Response to U.S. EPR Design Certification Application RAI 403, Supplement 11

Request for Additional Information No. 403(4439), Supplement 11

U. S. EPR Standard Design Certification

**SRP Section: 15.06.05 - Loss of Coolant Accidents Resulting From Spectrum of
Postulated Piping Breaks Within the Reactor Coolant Pressure Boundary**

Figure 15.06.05-61-1: Primary and Secondary Pressures

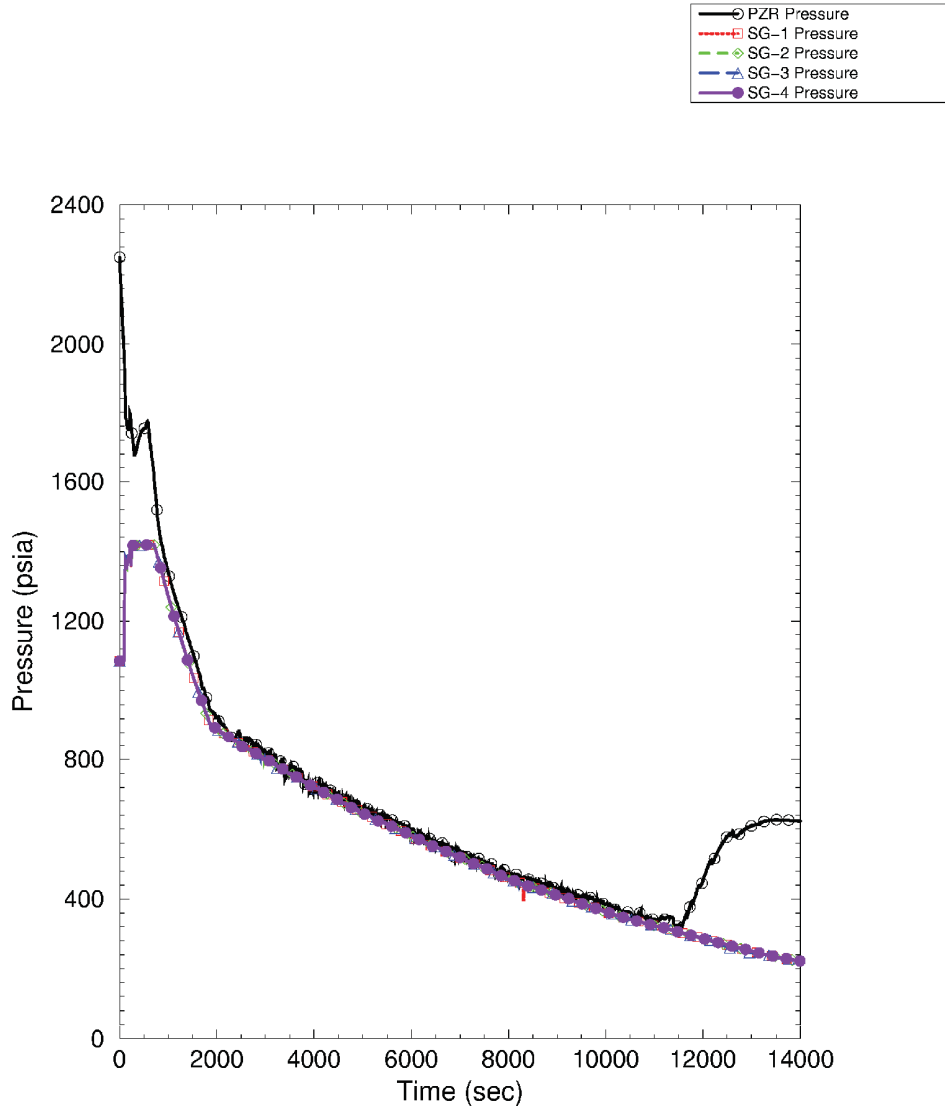
In response to Question 15.06.05-29, the applicant did not provide an assessment of the amount of condensate generated by reflux condensation as was requested. Instead, predictions for the liquid content in control areas defined as “steam generator (SG) outlet plenum,” “loop crossover pipe,” and “cold leg” were presented. Provide a calculation of the amount of condensate generated by reflux condensation accounting for conditions with emergency feed water (EFW) supply present for two or more SGs. The mass of steam due to decay heat is considerably larger than the volume of the loop seals. The staff requests a mass balance accounting for the steam generated in the core by decay heat, steam lost out the break, steam condensed in the SGs, condensate in countercurrent flow returned to the reactor vessel hot leg, condensate collected on the SG, loop crossover pipe, and cold leg, condensate lost out the break, and condensate transported to the vessel downcomer. The staff requests a description of situations involving stratified conditions in the cold leg and downcomer regions.

For the boron dilution event, the most important parameter relative to the reflux condensation is the volume of condensate that accumulates as a coherent, deborated slug. It has been conclusively shown, in the Primärkreislauf-Versuchsanlage (PKL) III tests, that the thermal-hydraulic phenomena occurring during the evolution of the event limit the volume of the slug size to the volume of the loop seal and steam generator (SG) outlet plenum. More discussion on these phenomena, and the applicability to the U.S. EPR plant, is provided in the Response to RAI 403, Questions 15.06.05-62 and 15.06.05-63. The volume corresponds to 11 m³ for the U.S. EPR plant. The total amount of condensate generated by reflux condensation is not unimportant though. The reflux condensation phase must be long enough such that the assumed slug volume can be created. Additionally, the condensate impacts the boron concentrations in the downcomer and in the core. The amount of condensate generated by reflux condensation is highly variable based on break size, system availabilities, and operator actions.

Additionally, systems analyses can provide a means to compare the effects of different break sizes, equipment availabilities, and operator actions. As described in the Response to RAI 403, Question 15.06.05-62, a spectrum of cases was analyzed with S-RELAP5 to determine the effect of these parameters on the transient evolution. Limiting characteristics were identified
